Permitting decisions- Refusal

We have decided to refuse the variation for Ugley Landfill Site operated by Biffa Landfill Solutions Limited.

The Environment Agency has decided to refuse the application for a permit variation (Ref: EPR/PP3735SW/V009) from the applicant.

Appendix 7 – Graph 1: leachate sump levels at leachate extraction wells

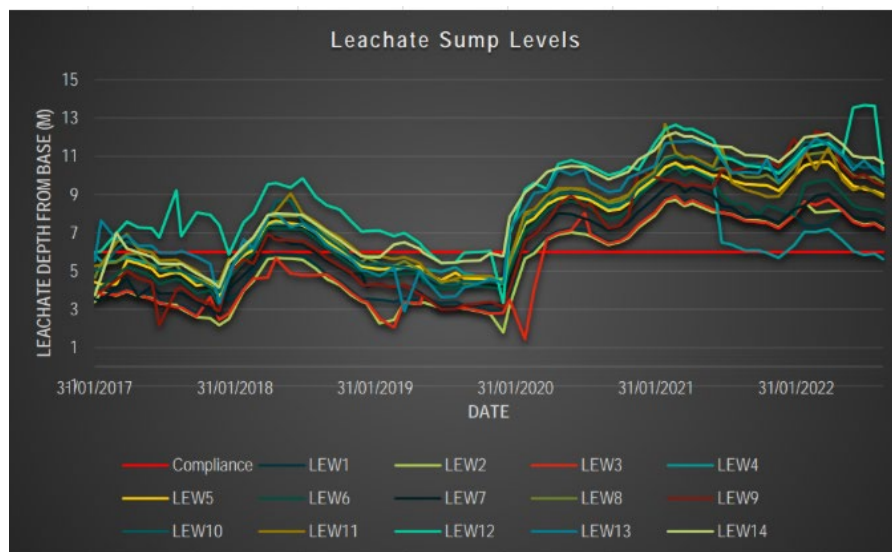
Notwithstanding the concerns we have with the validity of the applicant's leachate level data, the leachate levels presented in the graphical data plots suggest a sudden significant leachate level increase in all cells at the start of 2020⁷. The reasons for this sudden increase are not adequately explored or explained in the application.

Although part of the justification for the proposal is that infiltration through the landfill cap has increased, we consider it unlikely that a single event occurred to cause this increase in leachate levels⁷ at the start of 2020. The applicant has not provided any evidence of such an event occurring or provided a suitable explanation for the sudden leachate level increase.

The most likely cause of the raised leachate levels from 2020 onwards is a reduction in leachate extraction and removal from the site. The application failed to show adequate leachate removal of both legacy leachate and ongoing leachate production. Therefore, the applicant has failed to demonstrate that leachate levels will not result in pollution to groundwater and we are unable to grant a variation to the permit on this basis.

Appendix 10 – Proposed vs Pre-settlement Contours, ref: U3233500

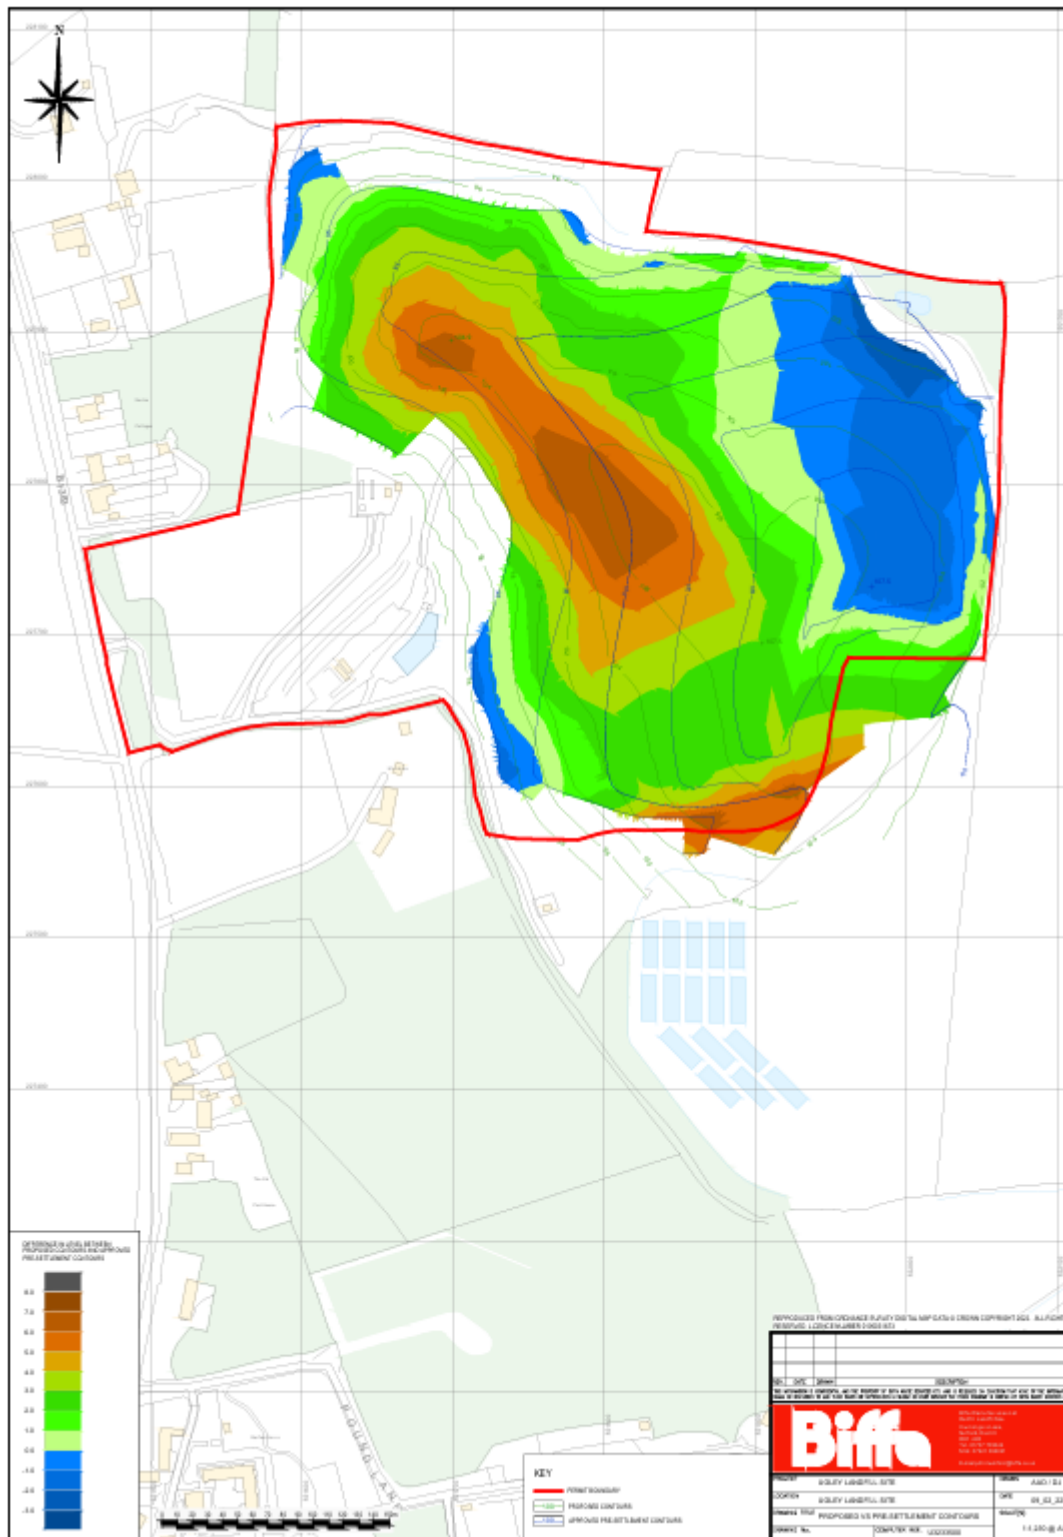
The waste to be placed as part of the proposed scheme will consist of additional material above the existing landfill cap as shown in cross section drawings on U3234400¹¹. Comparison of the proposed and existing (as shown on drawing U3233600¹²) topographic levels indicates that the thickness of the deposited material would vary across the site and would reach up to approximately 8m in some locations.

Appendix 12 – Proposed vs Existing Contours, ref: U3233600

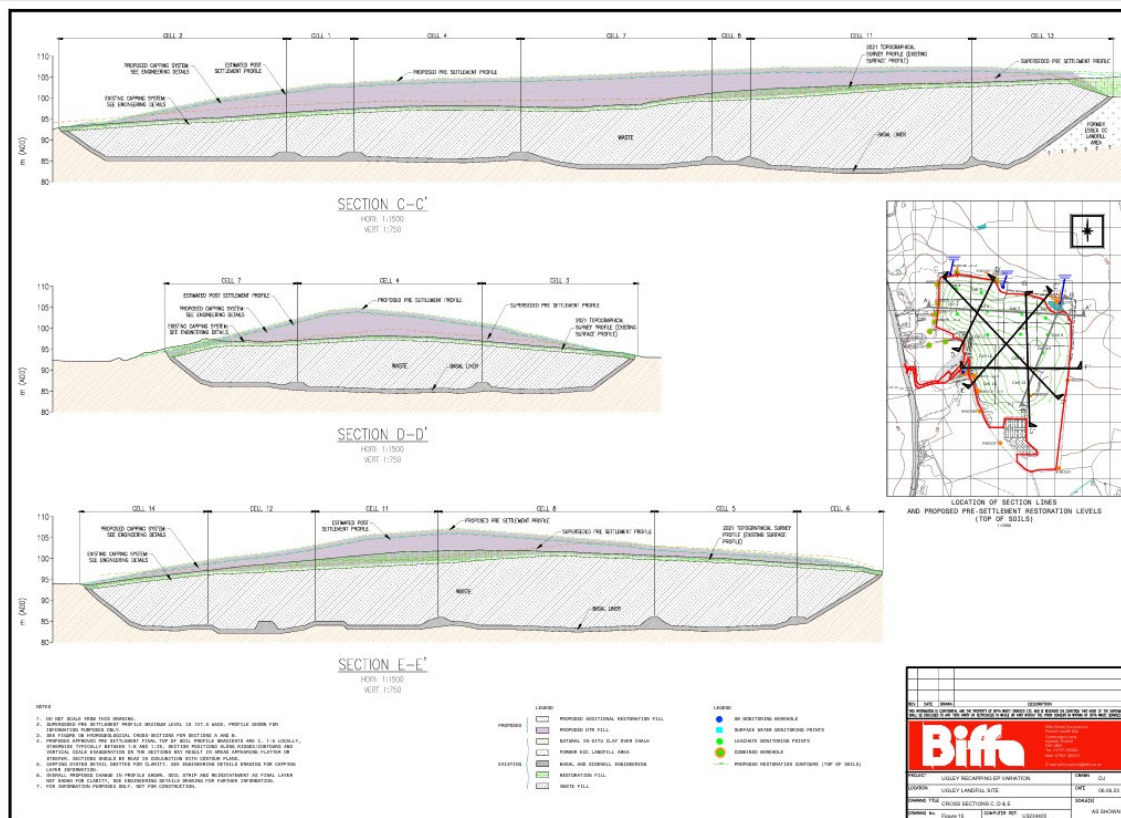
The application is inadequate because it does not include an assessment to show the impact on leachate levels from the compression of the additional waste (up to 8 metres of additional depth) on the landfill waste mass (waste surcharging). Published information and research is available to show that an average increase of 1 m in leachate level can occur as a result of the placement of a 2 m lift of material on a capped landfill (A geotechnical and hydrogeological assessment of the effects of the post-closure surcharge of Mountsorrel Landfill (UK), C. Dussek, N. Walker, J. Molyneux – in Proceedings Volume IV Sardinia 99, - Environmental impact, aftercare and remediation of landfills, Seventh International Waste Management and Landfill Symposium – T.H.Christensen, R.Cossu, R.Stegmann; CISA) (Sardina 99 paper).

The compression of the waste has the potential to increase leachate levels further, which will not achieve the aim of the scheme. The proposed deposit of 8

metres of waste in some areas of the landfill could result in up to an additional 4 metres increase in leachate levels.
